Review of Disposal System Inc., Proposed Method for the Determination of Health Based Limits for Waste Substances Not Covered in UIC Guidance No. 71

Review of Disposal Systems, Inc., Proposed Method for the Determination of Health Based Limits for Waste Substances Not Covered in UIC Guidance No. 71

J.A. Apps

January 1993

Figure 1. Logic chart for selection of HBLs.

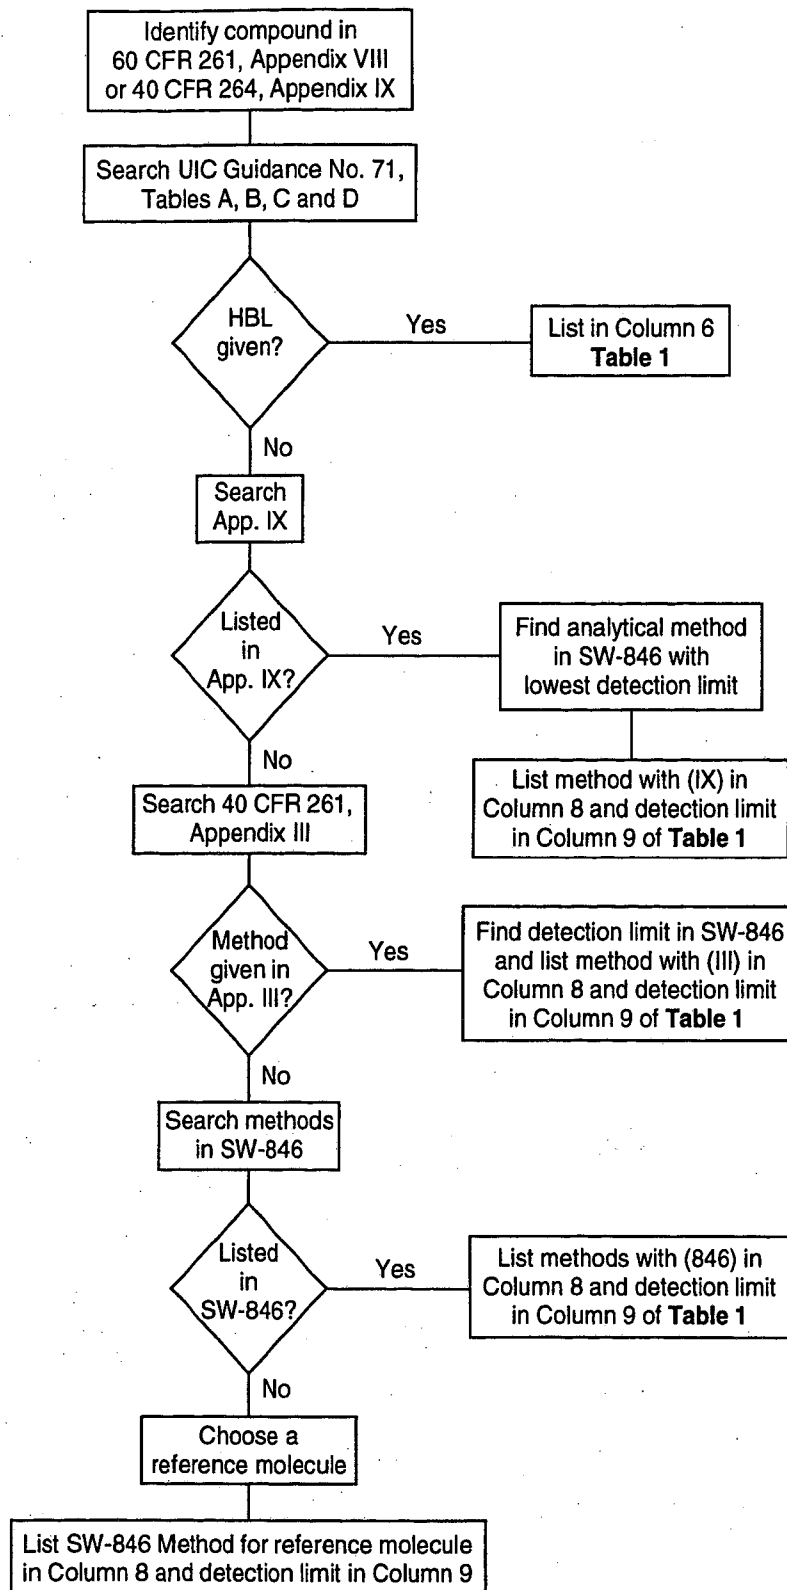
The next step was to evaluate all 442 compounds listed using the logic chart, to ensure that all HBLs and detection limits listed in **Table 1** were correct. The first problem identified was apparent confusion in the use of Tables A-D of the Appendix to UIC Guidance No. 71. Tables C and D list reference doses (RfDs) and risk specific doses (RSDs) respectively. Both RfDs and RSDs are defined in terms of the quantity of toxic contaminant or carcinogen, respectively, injected daily by an adult over a 70 year life span. Both dose rates are given in units of $\text{mg.kg}^{-1}.\text{day}^{-1}$. Conversion of these dose rates to concentration limits in drinking water is required before they can be compared with other HBLs. In UIC Guidance No. 71, the conversion factors are given in terms of the following equations:
